CASUA

Štursova 3

Current State

Floor plan and elevation

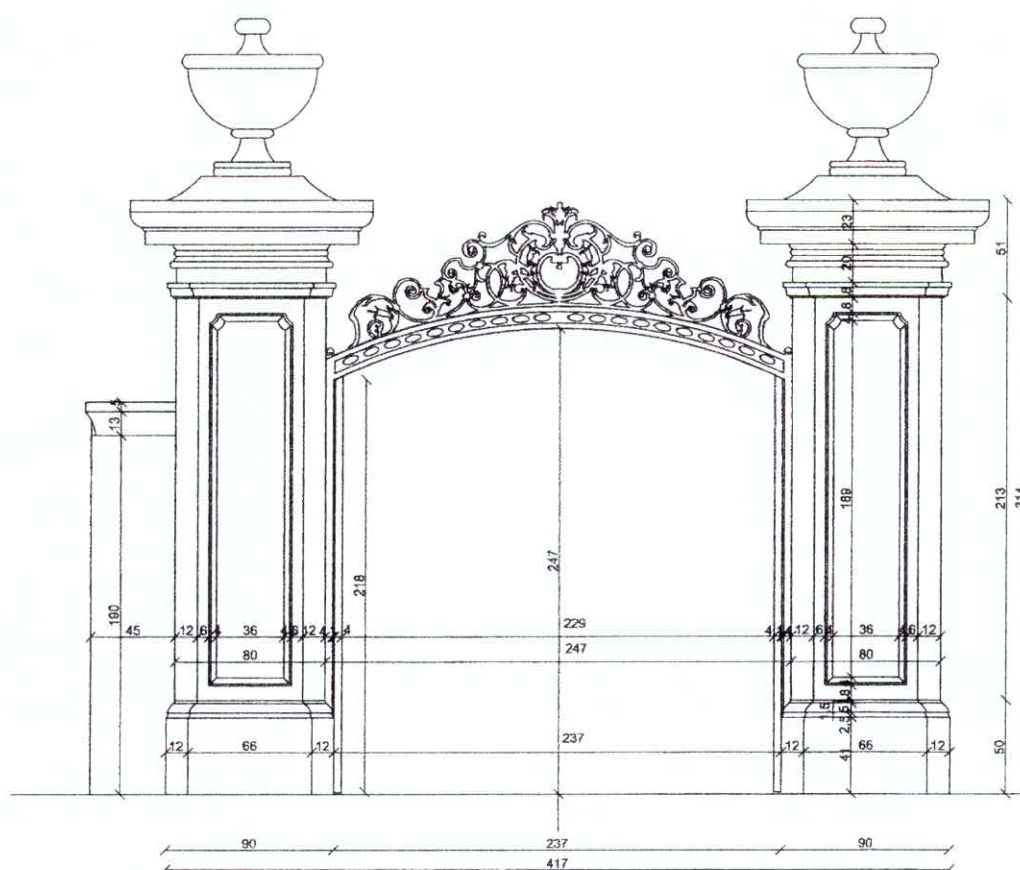
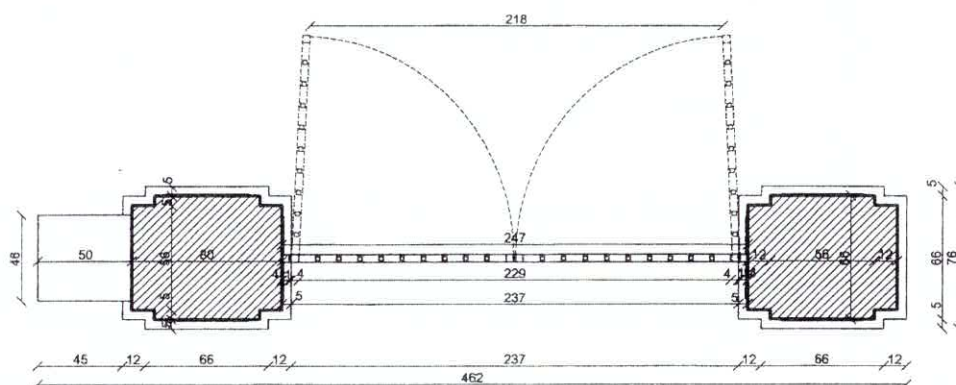
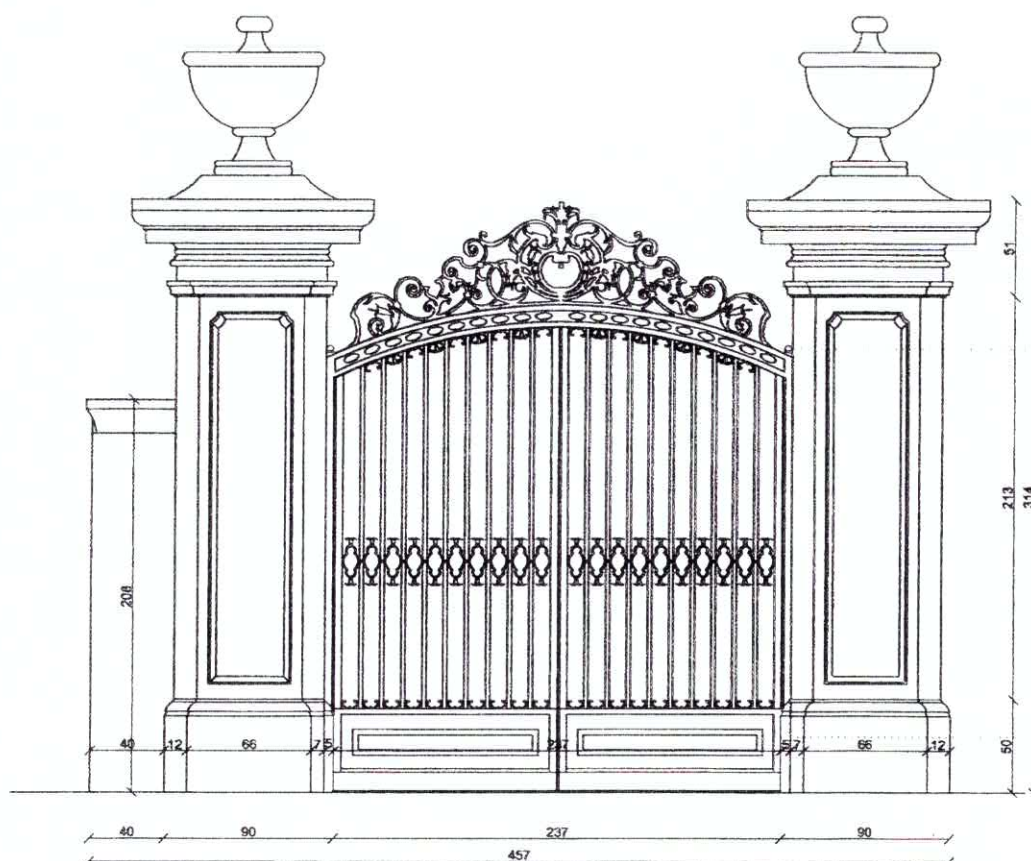
In this proposal entrance is made wider as the gates are replaced on the inside part. Additional elements for the gate would be installed in order to make a joint with the pillar. Down elements of the pillar would be removed with the wight of 5cm from both sides so the entrance would be 247cm.
